Docket No. 50-344

IE Bulletin No. 80-20

FAILURES OF WESTINGHOUSE TYPE W-2 SPRING RETURN TO NEUTRAL CONTROL SWITCHES

FIGURE 1

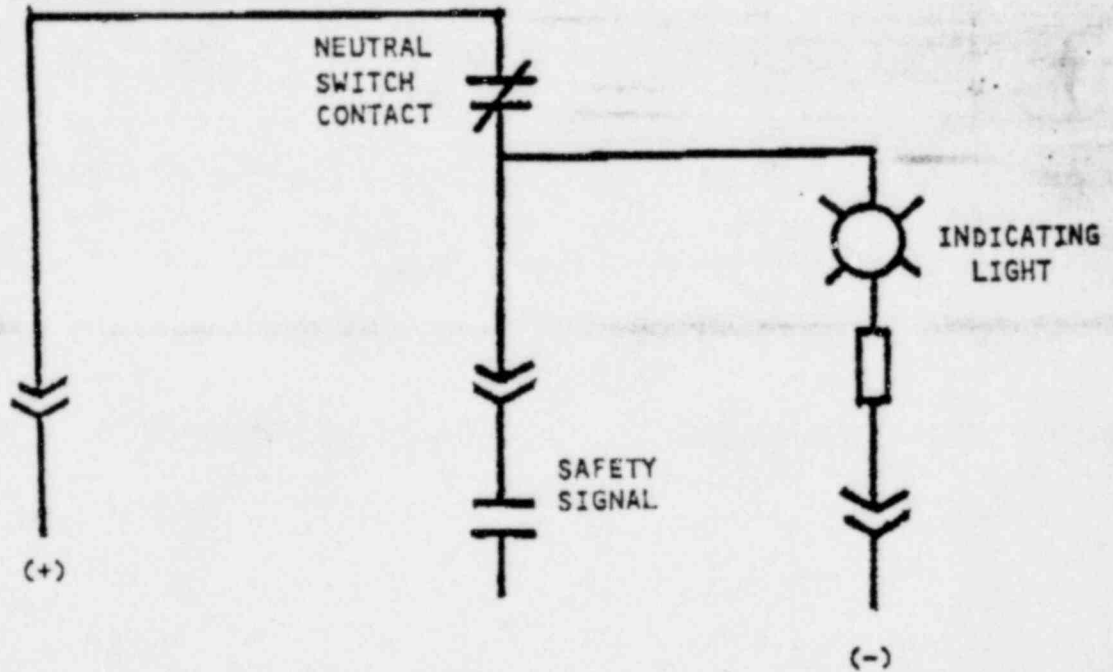
A review of this matter by Westinghouse led to the issuance of NSD Technical Bulletin No. NSD-TB-80-9 to the utility owners of all Westinghouse operating plants. The recommendations contained in the Westinghouse technical bulletin include: (i) testing the neutral position contacts of the subject W-2 switches for continuity, and (ii) rewiring of the indicating light circuit to permit the early detection of a neutral contact failure as shown in Figure 1.

Depending on how the indicating light circuit is wired, loss of continuity thru the neutral position contact of a W-2 switch could remain undetected until the equipment associated with the switch were called upon to operate. Since such a failure would be equivalent to by-passing the system associated with the switch, consideration should be given to rewiring the switches used in safety-related applications as shown in Figure 1. Such rewiring would provide an acceptable means for detecting contact failure, provided the indicating light is in the control room and readily visible by the operator. If the indicating light is not so located, consideration should be given to annunciating the neutral position contact failures at the control room to alert the operator of the inoperable status of a safety-related system. In addition, consideration should be given to adding redundant contacts to the W-2 switches or to replacing the W-2 switches with others having a more positive contact wiping action.

3. Licensees of operating plants and holders of construction permits shall describe the longer term corrective measures planned and the date by which such measures will be implemented by actual installation or by design change, as appropriate. As a minimum, the longer term corrective measures should include rewiring the indicating light as shown in Figure 1 provided the light is readily visible to the control room operator. If not, failures of the neutral position contacts should be annunciated in the control room.
